UNITED STATES PATENT AND TRADEMARK OFFICE

Office Action Summary

10/587,445

RAMSAUER, DIETER

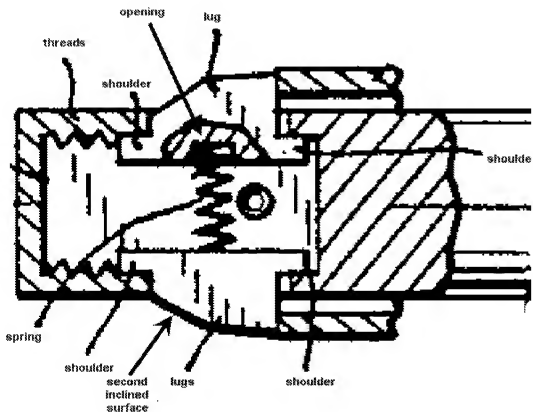
Young discloses an alternative and similar connecting device. Young discloses:

- a head part 36, such as a flange, which overlaps a rim of the opening of the thin wall on an outer side (figure 2);
- a body part 35 which proceeds from the head part 36 and can be pushed through the opening in the thin wall (figure 2); and
- a holding part (lugs 40) which is carried by the body part 35, supported on another rear side of the thin wall (figure 2), and is separate from the body part 35;

said holding part 40 being formed by holding elements (lugs) which project in a resilient manner (via spring 41) from the body part 35 in the direction of its outer surface (figure 5) and whose free end has a second inclined surface 42 which enables the holding part and the body part to be pushed through the opening, the inclined surface being inclined with respect to a plane of the thin wall (figure 1);

wherein the holding elements (lugs) are formed by two flat metal pieces lying next to one another, each metal piece having a rectangular opening or breakthrough (for the lug to expand through the surface of the attachment device), these two openings or breakthroughs together forming a rectangular space which receives a spiral pressure spring 41 by at least a portion of its diameter.

Please see the designations of figure 5, as shown below. Young discloses a singular inclined surface on each holding part, which allows for easy insertion. Young does not disclose a second inclined surface.
